Technical Service Information

THM 4T60E CONVERTER DISCOLORED - NEW COOLER FITTINGS

Figure 1

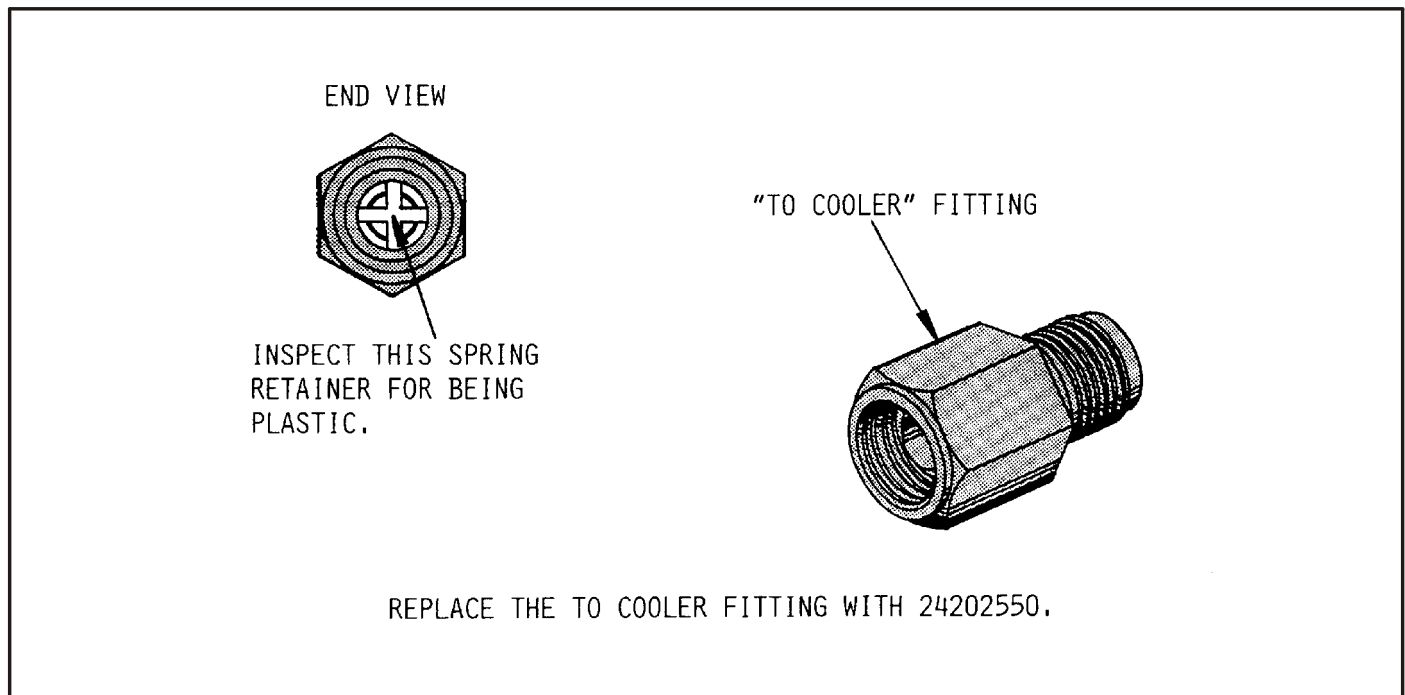
COMPLAINT: Some 1991-1994 vehicles equipped with the THM 4T60-E transaxle, may display a torque converter that is discolored, and turned Blue or Black.

CAUSE: The cause may be, the plastic spring retainer located inside of the "TO COOLER" (Large) fitting has melted, and is blocking and/or restricting cooler flow.

CORRECTION: Remove the "TO COOLER" (Large) fitting and inspect the spring retainer inside the fitting, as shown in Figure 1. If the spring retainer is plastic and/or melted, replace the fitting with OEM part number 24202550, which has a steel retainer. It is advisable to replace the "TO COOLER" fitting, even if the spring retainer is not melted, IF it has the plastic spring retainer. If the spring retainer is melted, the cooler in the radiator needs a thorough flushing, and possibly replacement.

Cooler Line Fitting (Steel Spring Retainer) 24202550
